Re: Reevaluation Report
Horse Valley Road Horizontal Directional Drill Locations (S2-0157)
Permit No. E50-258
Toboyne Township, Perry County

**HORIZONTAL DIRECTIONAL DRILL ANALYSIS
HORSE VALLEY ROAD CROSSING
PADEP SECTION 105 PERMIT NO. E50-258
PA-PE-0002.0000-RD & PA-PE-0002.0000-RD-16
(SPLP HDD No. S2-0157)**

PRODUCED WATER CONTAINMENT, CONTROL, AND FILTRATION

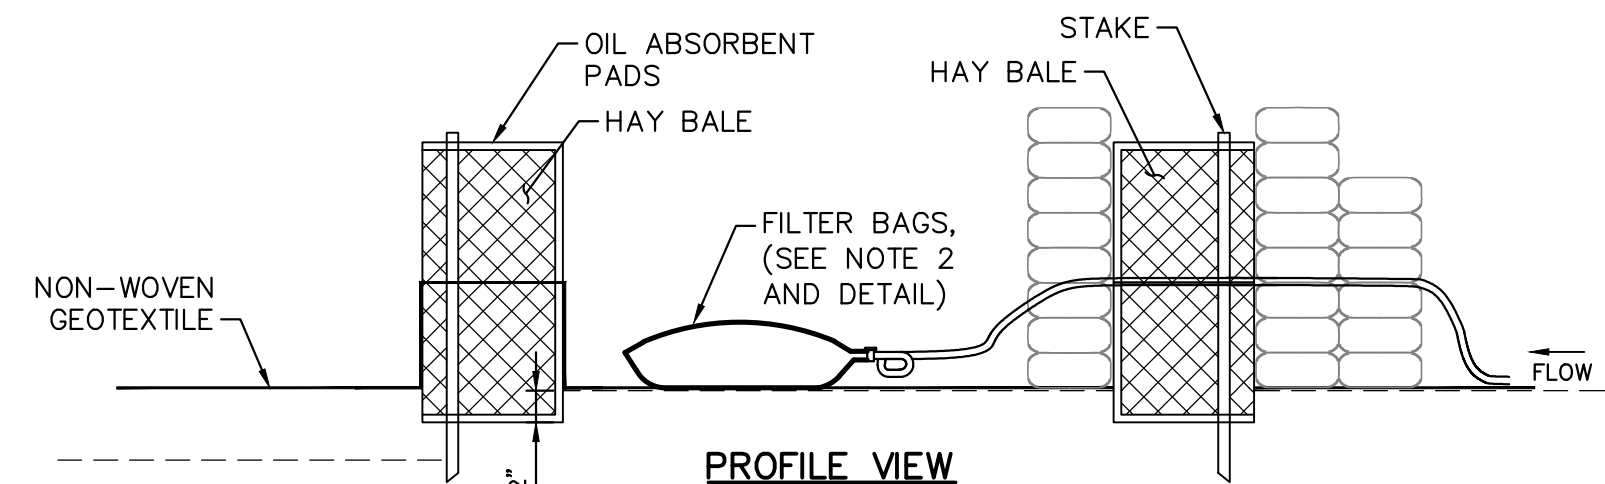
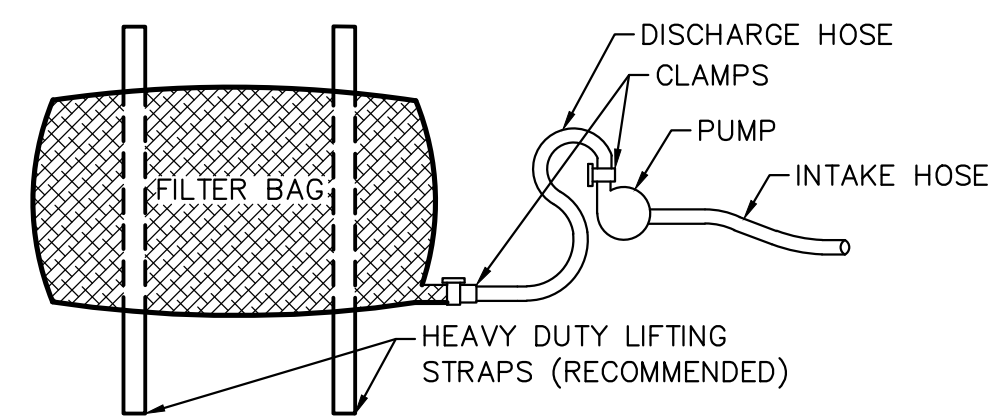
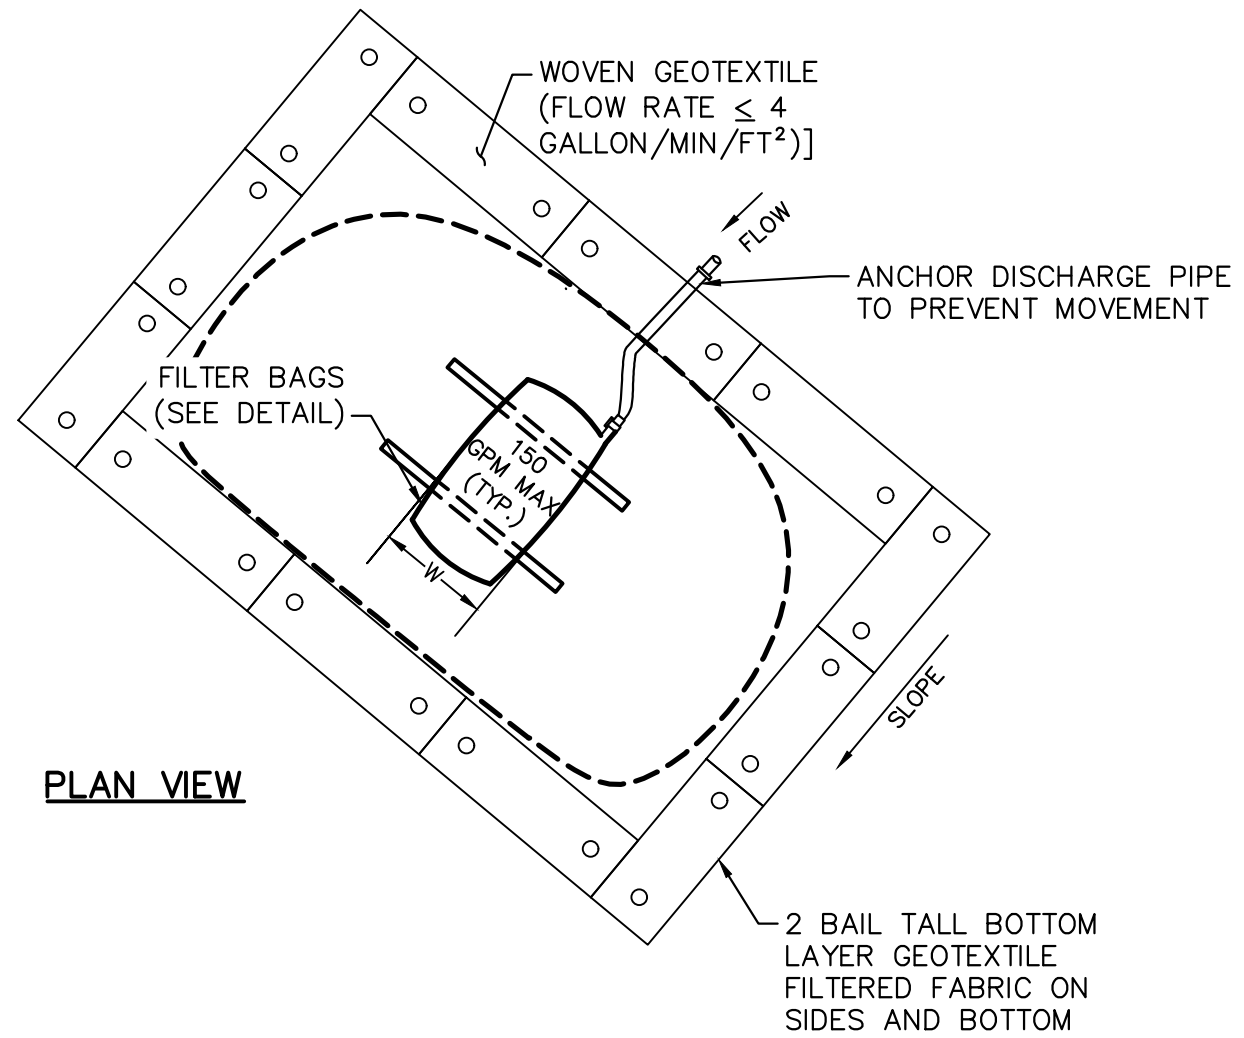
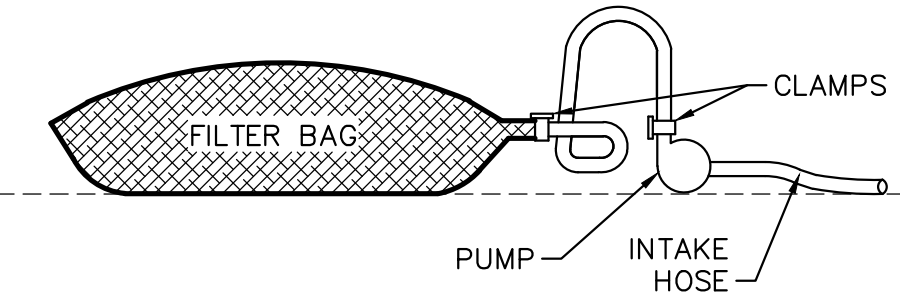
Finally, a revised and corrected Hydrogeology Report is included as Attachment 1. Attachment 2 presents the revised E&S sheets detailing the water management control locations,

and details on the discharge filtration structure. A water supply illustration is presented in Attachment 3. The original and revised HDD Plan and Profile are now in Attachment 4.

**ATTACHMENT 3
WATER SUPPLY ILLUSTRATION**

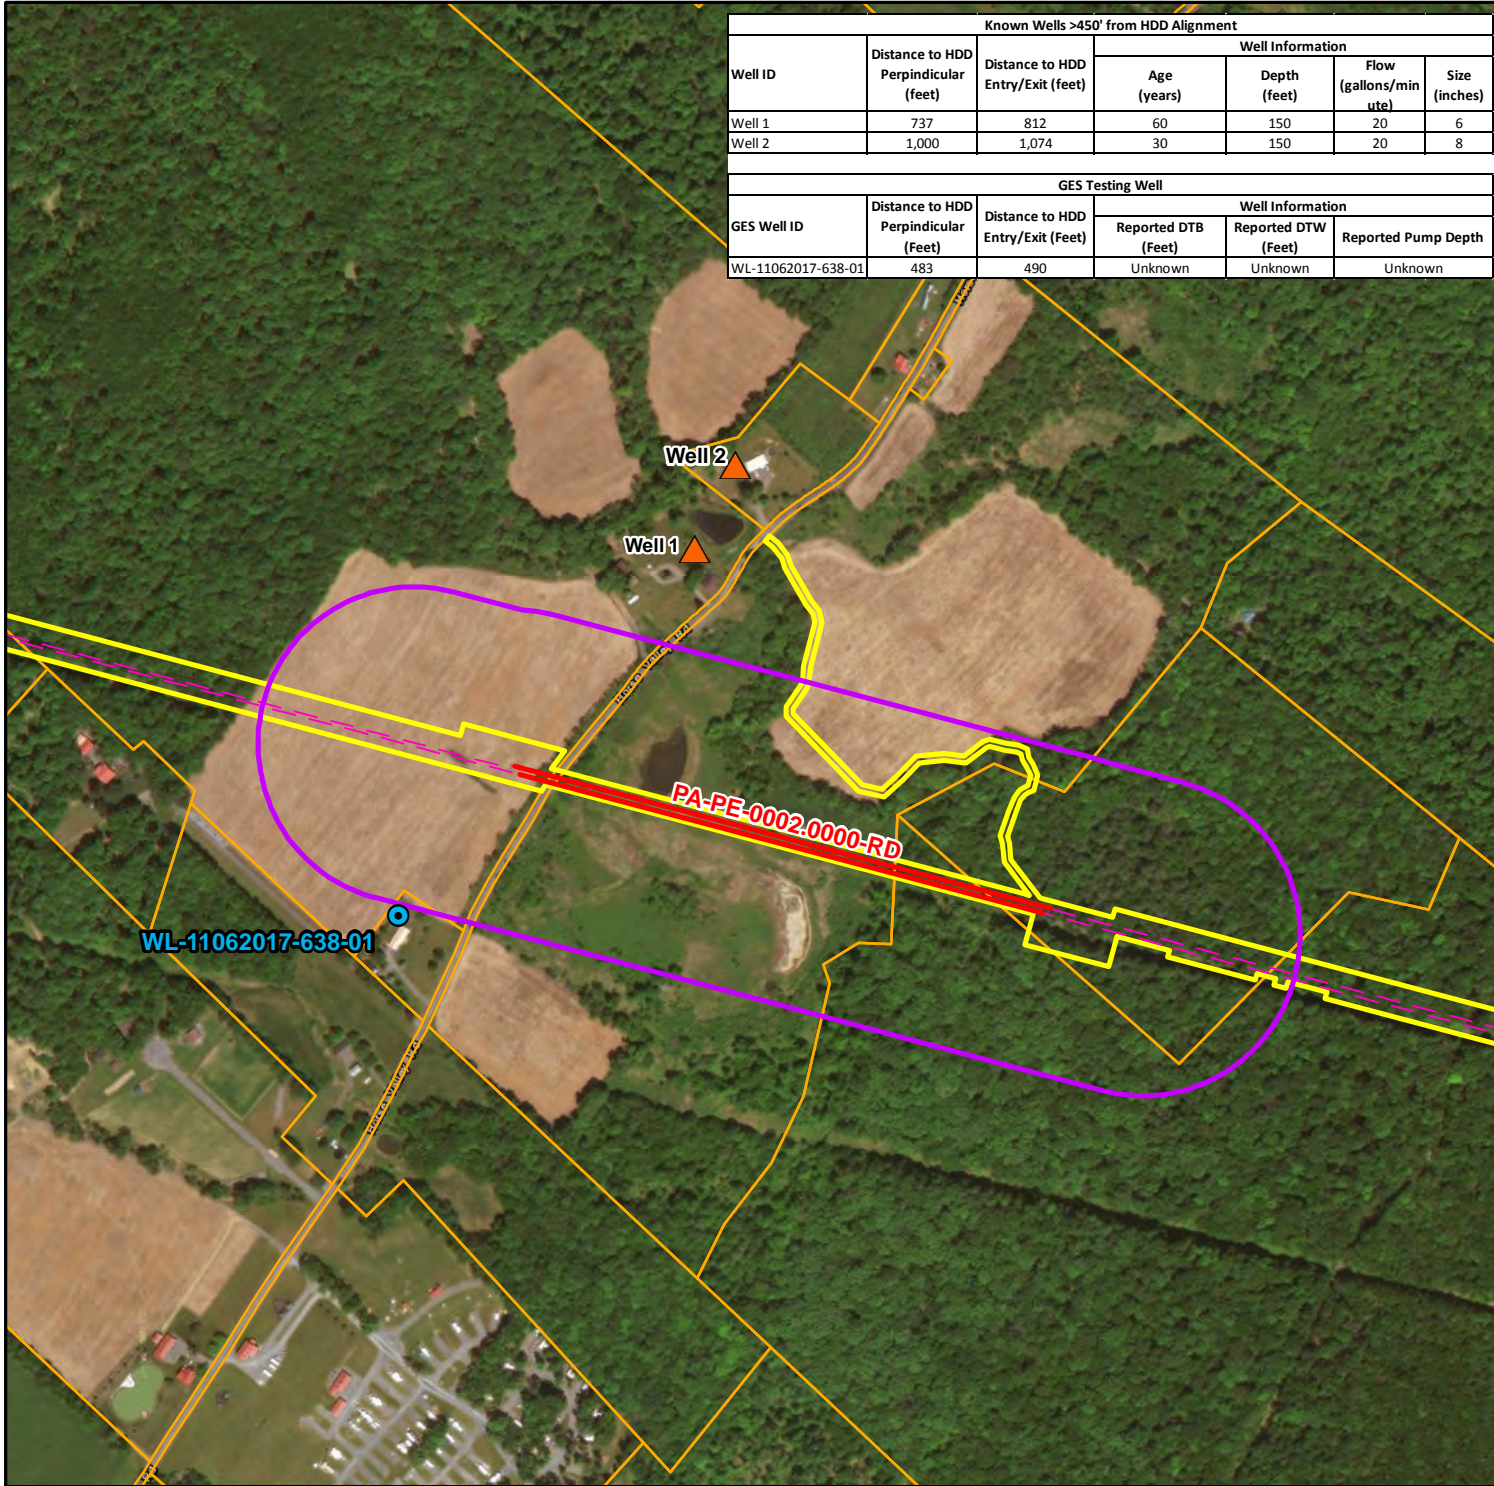
Through prior communications, SPLP was aware of the non-community public water supply approximately 1600 foot (ft) south of the work location. The discussion within the Adjacent Features section of the analysis has been enhanced to provide an analysis of risk for this water supply. SPLP conducted a direct investigation of the reported non-community public water supply 800 ft to the north, and on these properties, there are two private water wells serving individual residences. The analysis of risk for these two wells has been added to the Adjacent Features section.

On January 2, 2018, agents for SPLP investigated the two occupied properties north of the HDD location. A non-public community water well was not observed at either location. Both locations, as shown on the water supply illustration, have private wells that serve single, residential home sites. Based upon the understanding of the groundwater levels and movement through the overburden and subsurface bedrock fissures and bedding plane partings as described in the hydrogeology report, SPLP believes that HDD activities could affect individual well use during active drilling for wells located within 150 linear ft. of the profile. Neither of these wells are within this zone of concern, and both are located upgradient and west of the valley floor; therefore, the source recharge for these wells would derive from groundwater movement from higher elevations to the west, not from the direction of the HDD profile where is crossed the valley floor.
